**From:** Leonard Braman <[lbraman@wrkk.com](mailto:lbraman@wrkk.com)>  
**Sent:** Friday, December 15, 2023 10:44 AM  
**To:** Blessing, Ralph <[RBlessing@StamfordCT.gov](mailto:RBlessing@StamfordCT.gov)>  
**Cc:** Mathur, Vineeta <[VMathur@StamfordCT.gov](mailto:VMathur@StamfordCT.gov)>  
**Subject:** 12-18 Taylor Street

PROJECT	<b>RESIDENTIAL DEVELOPMENT</b>
PREPARED FOR	<b>G&amp;T TAYLOR STREET LLC</b>
LOCATION	<b>12 &amp; 18 TAYLOR STREET, STAMFORD, CONNECTICUT</b>
1 OF 5	<b>GRADING PLAN</b>

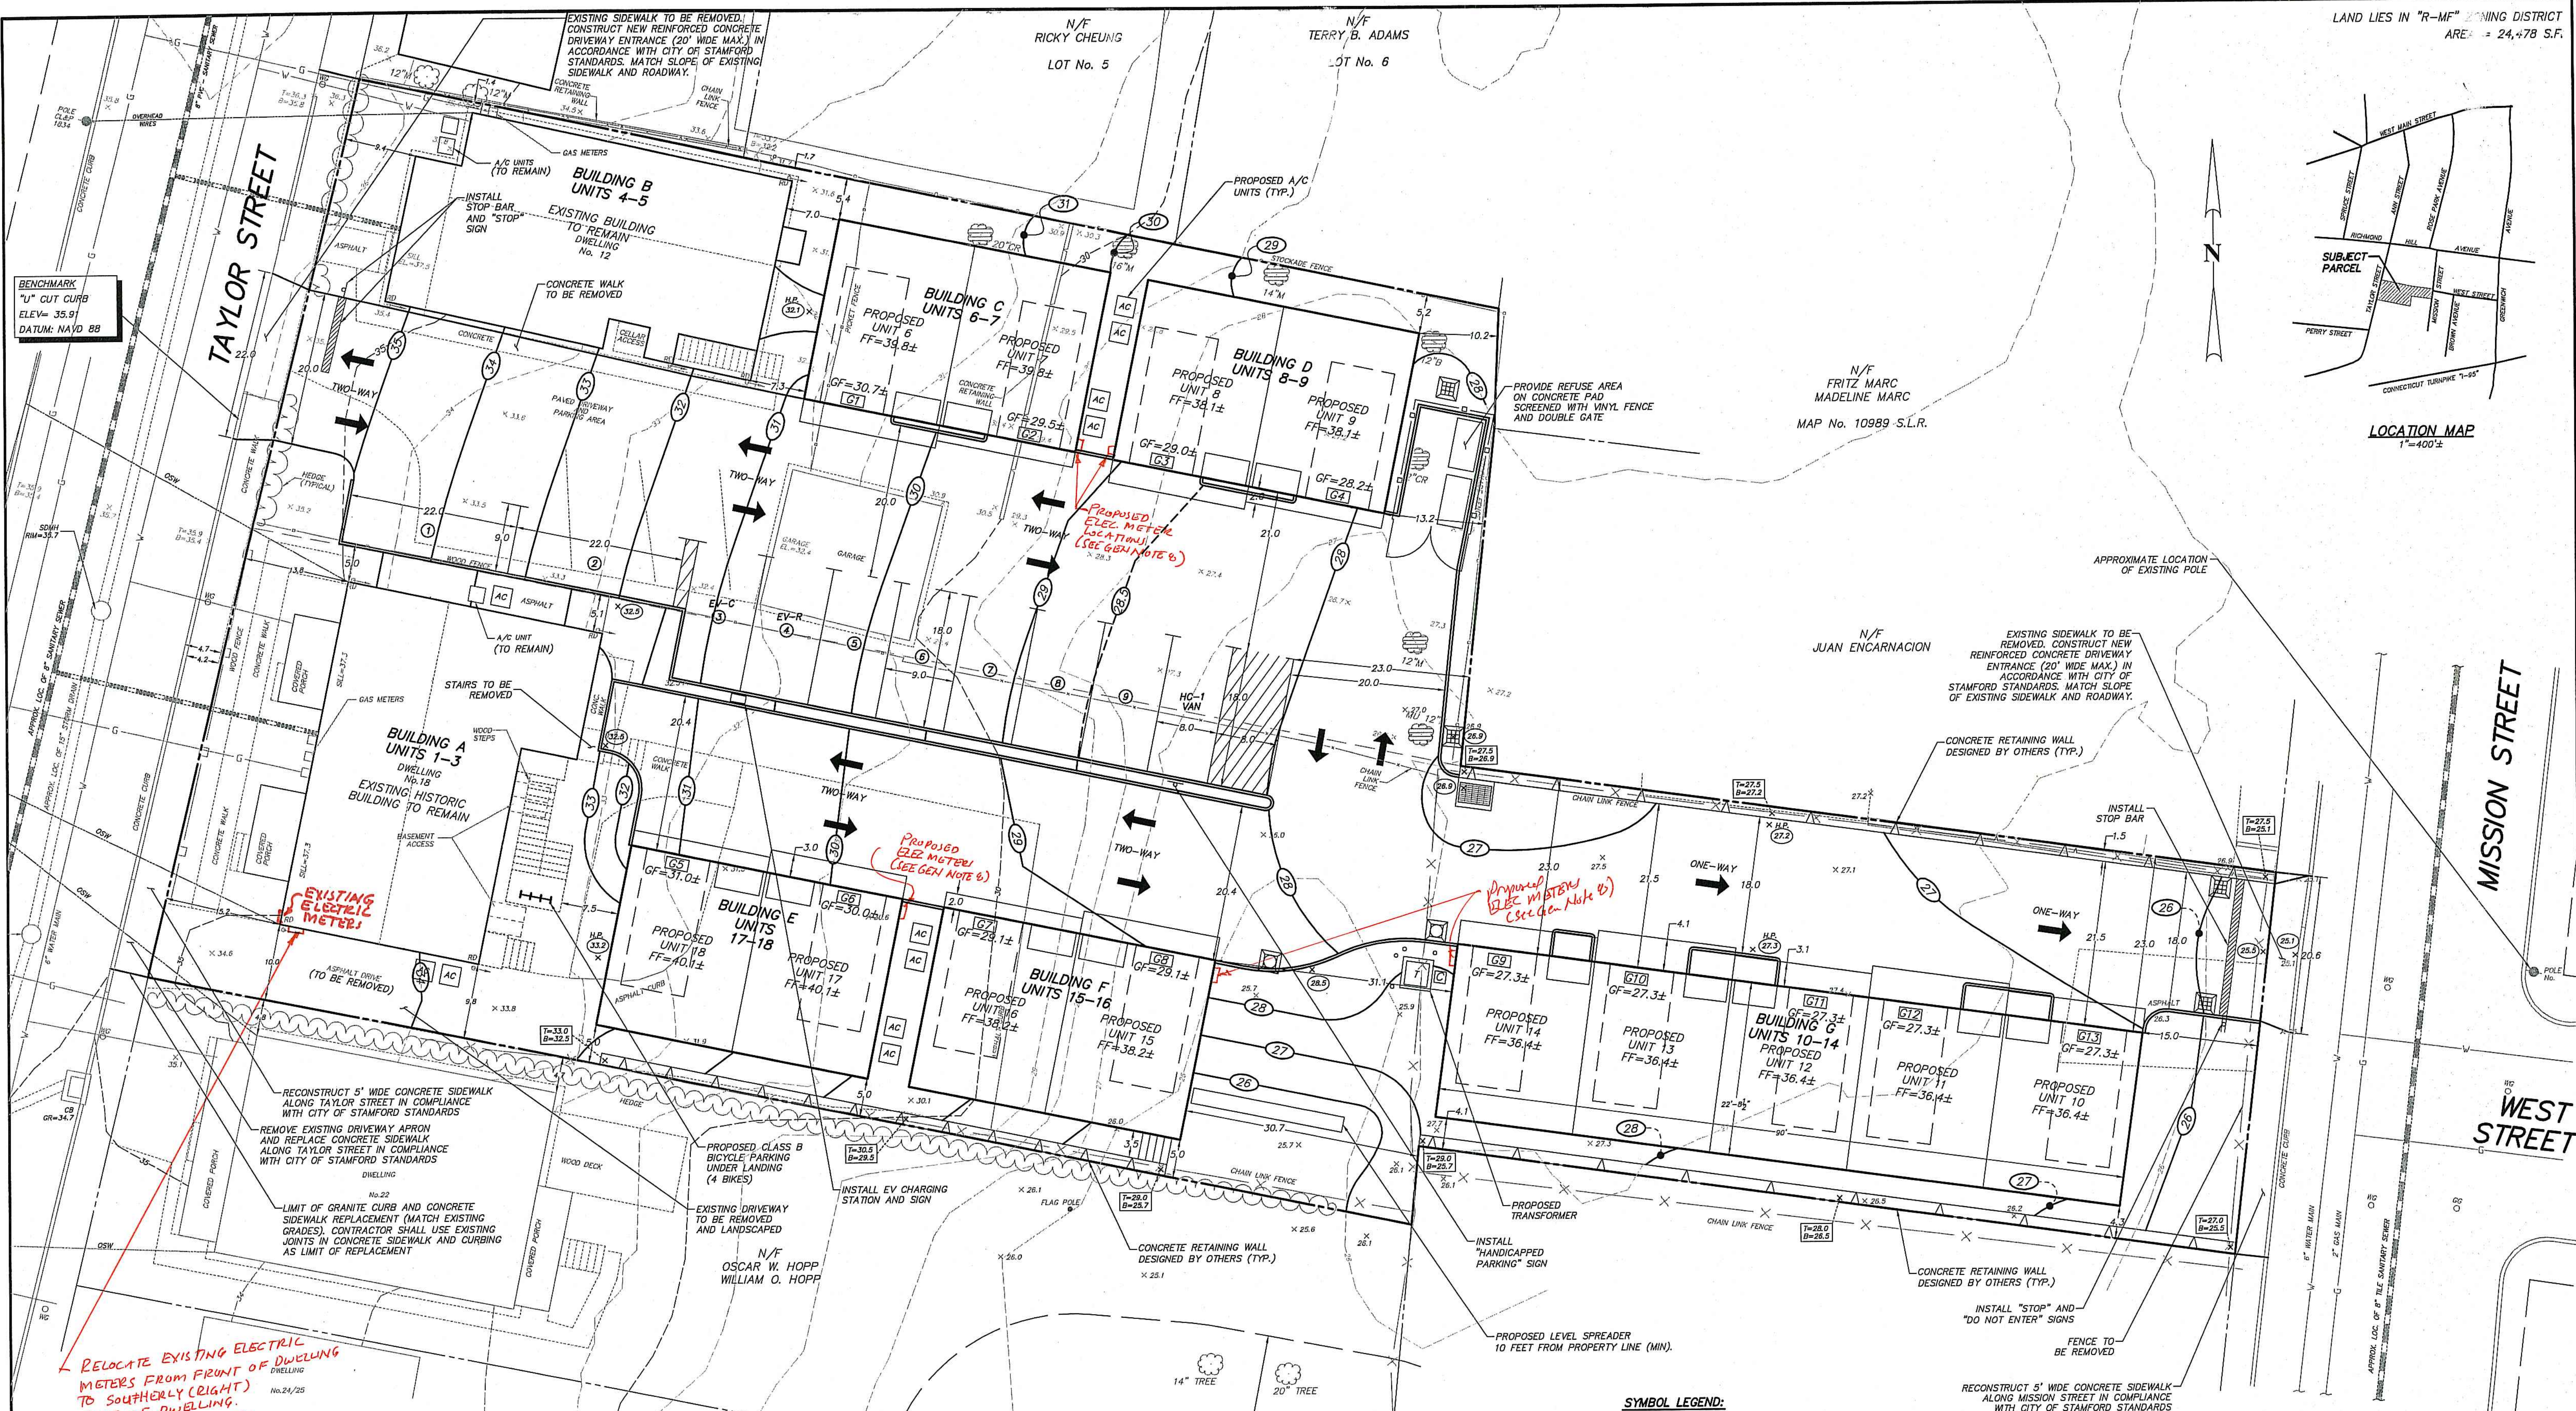
*Add the following notes*  
 7. COORDINATE THE RELOCATION OF EXISTING METERS ON BUILDING A TO THE SOUTHERLY SIDE OF DWELLING WITH EVERSOURCE.  
 B. ELECTRIC METERS FOR BUILDING SHALL BE INSTALLED ON THE WEST SIDE OF THE BUILDING, COORDINATE WITH EVERSOURCE. COORDINATE ALL OTHER METER INSTALLATIONS FOR BUILDINGS C, D, E AND F WITH EVERSOURCE

*RELOCATE EXISTING ELECTRIC METERS FROM FRONT OF DWELLING TO SOUTHERLY (RIGHT) SIDE OF DWELLING. (SEE GENERAL NOTE 7)*

*PROPOSED ELEC. METERS (SEE GEN. NOTE 6)*

*PROPOSED ELEC. METERS (SEE GEN. NOTE 6)*
